TOWN OF KIAWAH ISLAND
BOARD OF ZONING APPEALS
AGENDA FOR January 22, 2018
4:00 P.M.

Case # BZA-12-17-00233

Case # BZA-12-17-00233
BZA Meeting of January 22, 2018
Subject Property: 56 River Marsh – Kiawah Island

Proposal: Variance request for the reduction of the required graphic rear yard setback for approximately 190 sq. ft. encroachment for a prospered rear deck addition.

A100

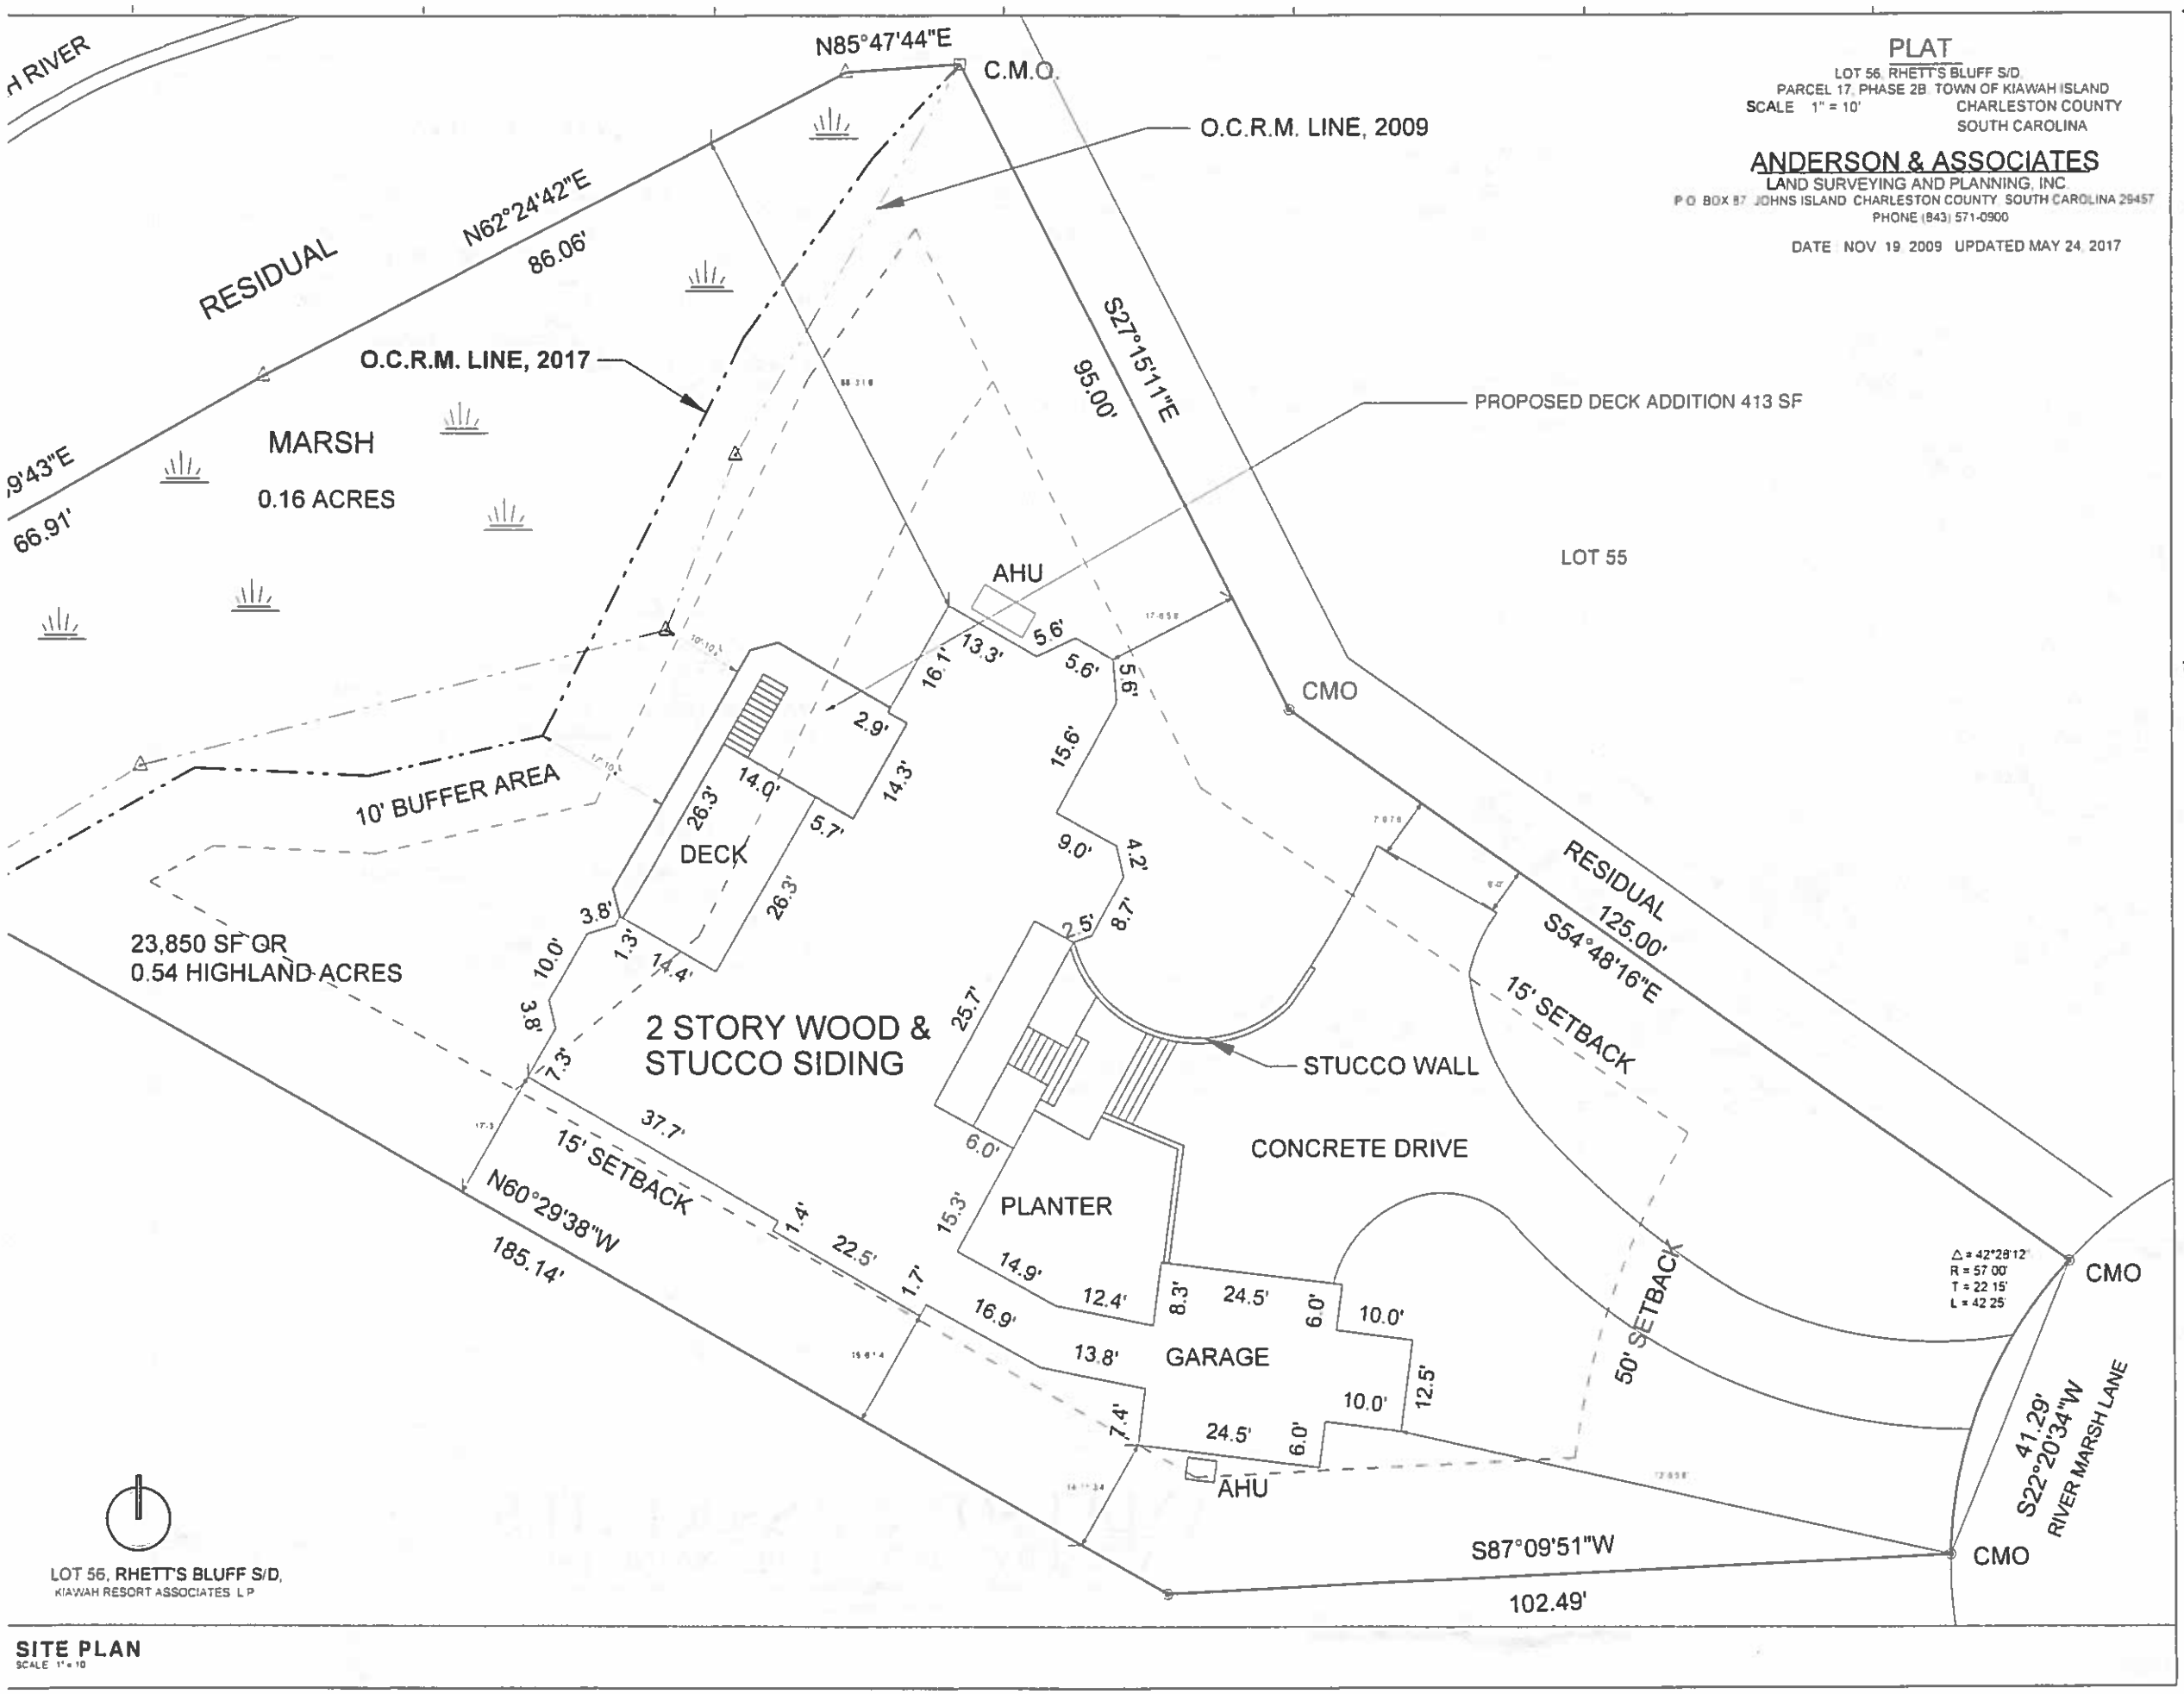
- The ARB has approved for the deck addition to encroach three feet further with 190 square feet of area in the rear setback; The ARB also approved the revised elevation of the existing deck encroaching the rear setback. The ARB has also approved for this proposed addition to increase the lot coverage of the home from the existing 34.4% to 36.0%. This increased lot coverage may require approval of the Town of Kiawah Island's Board of Zoning Appeals.

- With the proposed change in the mass of the rear of the home, the rear yard landscape needs to be updated to buffer the outdoor living spaces from neighboring areas with multi-layered native evergreen shrubs. A proposed Preliminary Landscape Plan should be submitted for review and approval with the permit submittal. A Final Landscape Plan will then be submitted for review and approval 60 days prior to commencement of associated work.

- Due to the proposed change in footprint, please be reminded that an as-built survey will be required for the final inspection at the conclusion of construction.
